Techno-Economic Assessment Study Rogun HPP

Phases 0 & 1 Considerations
and Assessment Status Update

Engineering and Dam Safety Panel of Experts

Engineering and Dam Safety Considerations by Panel of Experts

POWERHOUSE CAVERN

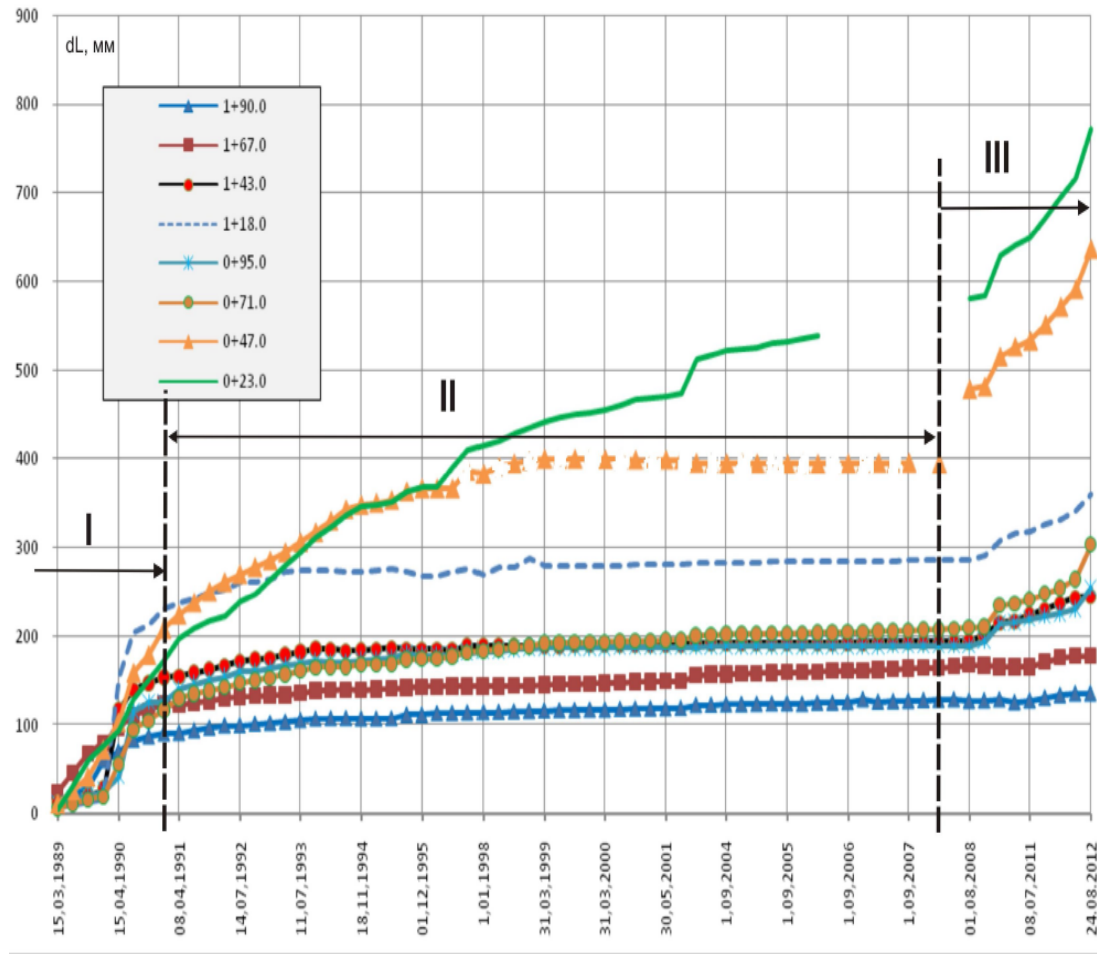
- The machine cavern is located in sandstone and siltstone, the latter mainly occurring in the area of Units 5 and 6. It is approximately 21m wide, 69m high and 220m long. A significant amount of excavation has been already conducted (more than 30m in height)
- Time dependent deformations have been exhibited since the late 80's and questions were raised about an increasing creep behavior and the possibility of compromised stability mainly in the siltstone section.
- An independent site inspection and evaluation of conditions and convergence measurements was undertaken by the PoE in April 2013, in conjunction with a sampling campaign by the Consultant.

- Significant wall convergence has been recorded amounting to 600mm in the siltstone sections up to the middle of 2008 and about 750mm up to August 2102.

The convergence should correspond to the closure of the opening of the cavern and not to the convergence of its wall.

- The PoE suggested, after the inspection in April 2013, the possibility of progressive distress of the rock mass in association with the ageing of the strengthening measures applied since the late 80s, to be the reason of the time dependent deformation and not a gradual deterioration of the petrographic quality due to softening of the siltstone. Such a state could be addressed efficiently by additional support in the sidewalls.
- The PoE concurred with undertaking numerical modelling with all new data from measurements and laboratory test results by both HPI (3D model) and the TEAS Consultant (2D model) to resolve the feasibility of implementation of Units 5 & 6 in the siltstone zone.

The report of the Consultant recommends that cavern stabilisation measures for Units 5 & 6 are implemented prior to any further excavation in the caverns. The stabilisation measures will include:

- a) Installation of 35m long rock anchors on both sidewalls and in both caverns, above the current excavation level, starting from the crown downwards to reduce/limit the rate of movement, and
- b) Reinforcement and stabilisation of the highly de-stressed rock mass in the “pillar area” between the two caverns. This will be achieved by installation of the Multiple Packer Sleeved Pipe (MPSP) that will reinforce the rock mass, as well as be used for consolidation grouting.

The EDS PoE believes that with the implementation of the proposed stabilization works the stability of the caverns can feasibly be secured.

- a) Continue with the monitoring of the caverns' displacements;
- b) Update the numerical model to take into account the new displacement measures and the additional results of the laboratory testing;
- c) Define the extent of the proposed stabilisation works in the “pillar area”.
- d) Identify other feasible strengthening measures to the “pillar area” and allow adequate contingency funds in the cost estimate .
- e) In the view of the PoE strutting of the caverns, as excavation goes, is another solution that may also be implemented along with the new anchors
- f) Prior to detail design, undertake the in-situ testing of rock anchors, including creep pull-out tests on anchors and anchor heads and in-situ trial testing of the rock mass grouting. These activities should be included in the cost estimate of the stabilisation works.

*Distressing of the siltstones after excavation,
under the concrete struts*

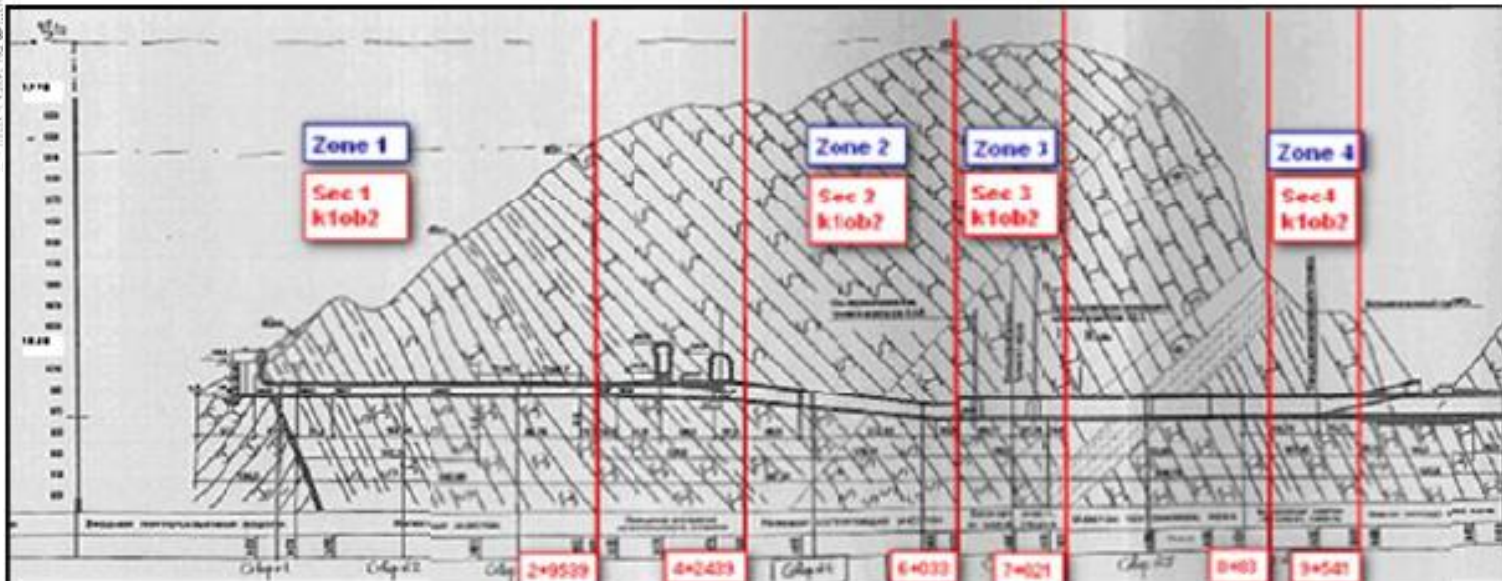
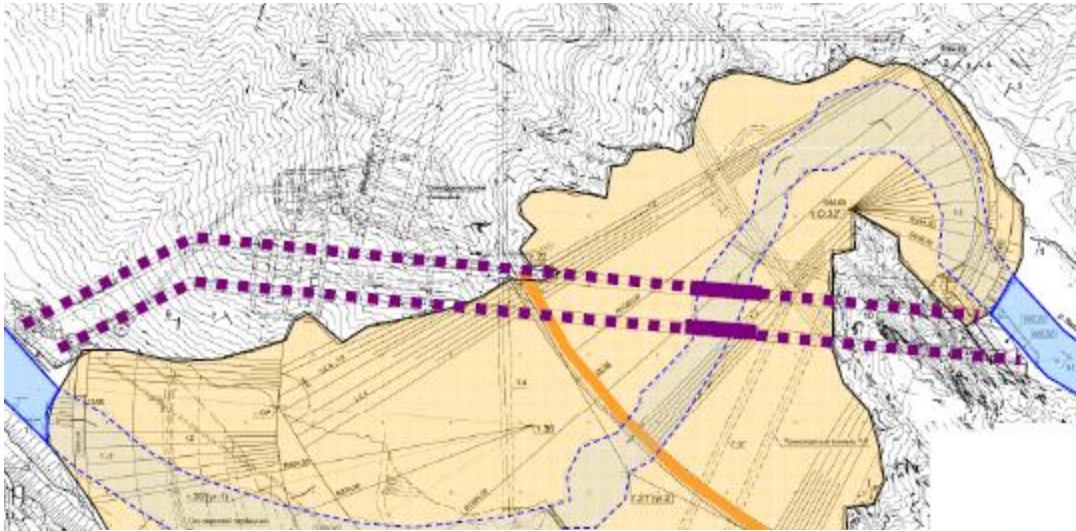
Cores of siltstone behind the concrete lining at +999.

*This area correspond in the upper part of the cavern, excavated 20 years earlier.
No change of the nature of the rock can be recognized.*

Diversion Tunnels DT1 &DT2

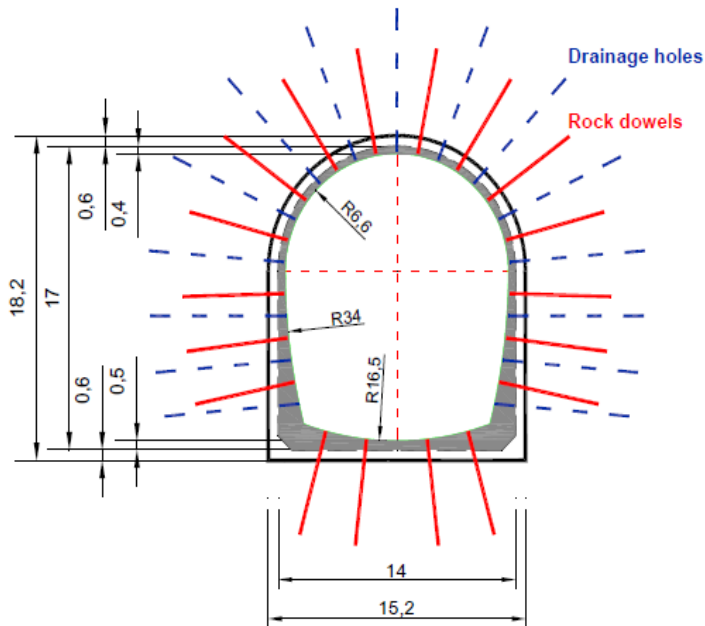
- Tunnel inspection;
- Testing (strength of the concrete lining & permeability of the rock);
- Assessment of the tunnel loading (rock, water & seismic loading) in accordance with international standards and compared with the original design.

- DT1 & DT2 do not fulfill the technical requirements in respect to safety and serviceability required by the presently internationally recognized design criteria and standards;
- The tunnels need substantial remedial works;
- Special consideration will need to be given to the areas where the faults F70 & F35 are crossed.

- Install drainage systems through the tunnels linings or drainage galleries;
- Strengthen the structure by adding additional reinforced concrete lining and fully grouted rock dowels;
- Install high strength rock bolts to stabilize the tunnel invert in some stretches;
- Additional grouting along the stretches where high rock mass permeability was measured;
- Install special measures where tunnels cross faults F70 & F35 which will enable relative movements of the tunnel segments.

- *Assessments undertaken;*
- *Methodology applied;*
- *Remedial works proposed, which have been applied to all alternatives.*

Other Underground Structures

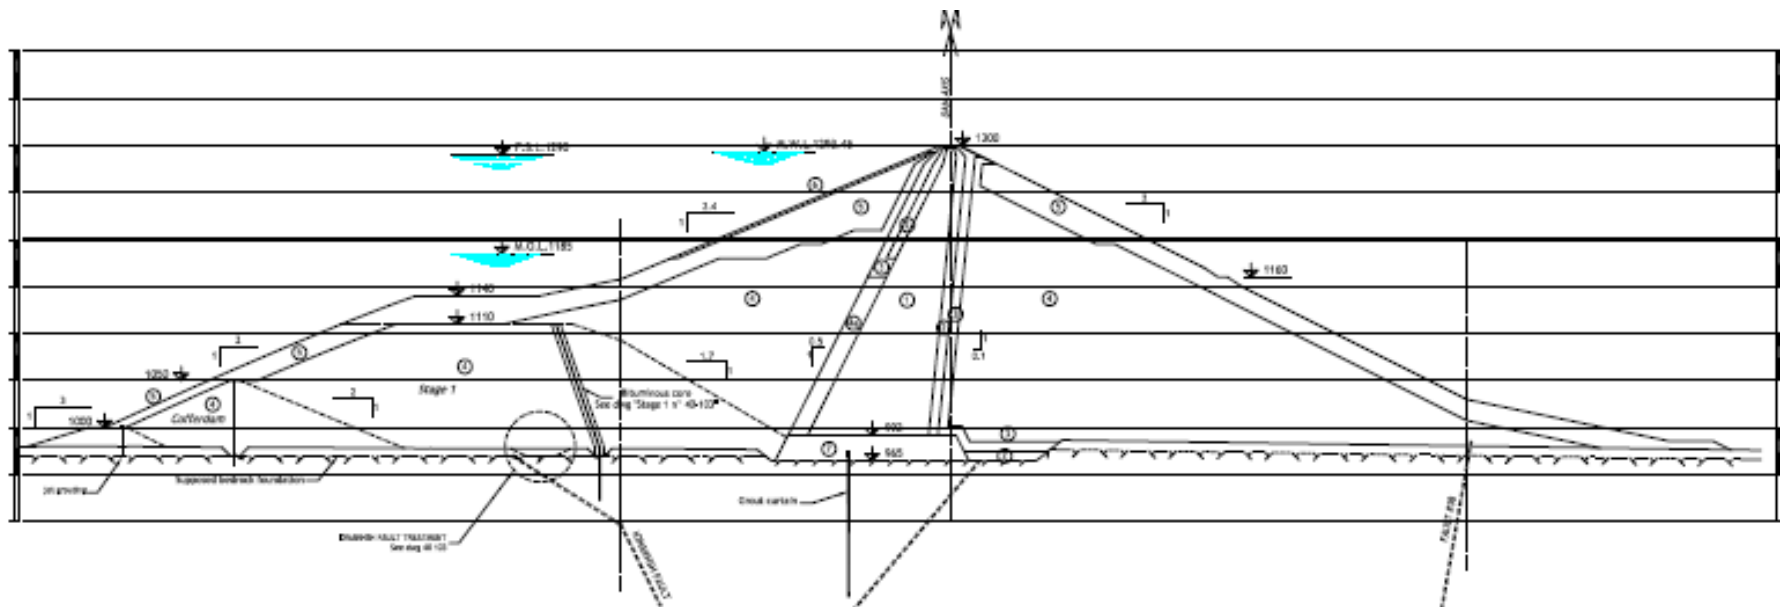
- Several other underground structures, mainly permanent and temporary transportation tunnels, were inspected in detail by the Consultant in order to record all defects and recommend possible remedial measures;
- No evidence of structural instability was noted;
- However, some defects were noted (honeycombing etc). While these deficiencies will need to be addressed, in general they do not impair the safety condition of the works;
- *EDS PoE agrees with the recommendations.*
